## Fort Belvoir Elementary School II

Final Site and Building Plans

# Analysis and Compliance – Applicant Response # 1

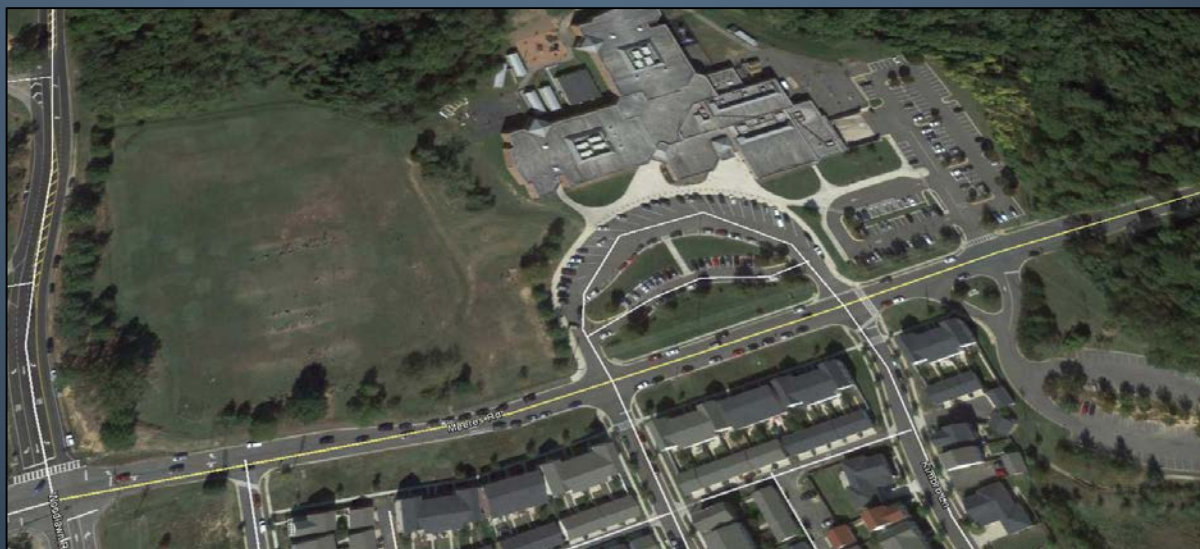
**Requests** the applicant to refine the proposed site plan to better address on-site and local area pedestrian circulation, and **recommends** the following specific revisions:

- Addition of a sidewalk connection between the Meeres Road/Woodlawn Road intersection and new school main entrance area, along the west-side of the new parking lot,  
Fairfax County Public Schools' Response: A sidewalk connection to the west side of the new parking lot is not feasible due to grade conditions. Access to the school from Meeres Road at the new main entrance has been provided.

There may have been some communication issues on this issue in the past. A site visit was conducted this week to review the existing conditions of the sidewalk at Meeres Road. We feel that you are talking about the existing asphalt path that runs parallel to Meeres Road and not north along the west side of the proposed parking lot? The existing bus loop exit will be removed upon completion of our site work during the summer of 2016. All of the existing asphalt trail that lies between the existing bus loop entrance and the new kiss and ride entrance to the new building will be replaced with 4 foot wide concrete sidewalk in the same location and grade. The existing asphalt trail that lies to the west of the new kiss and ride entrance to the new building will remain. There will not be any new access points within the perimeter fence from Meeres Road outside of the vehicle access points as shown. Please see the attached sheets SP1 and SP2 for clarification.
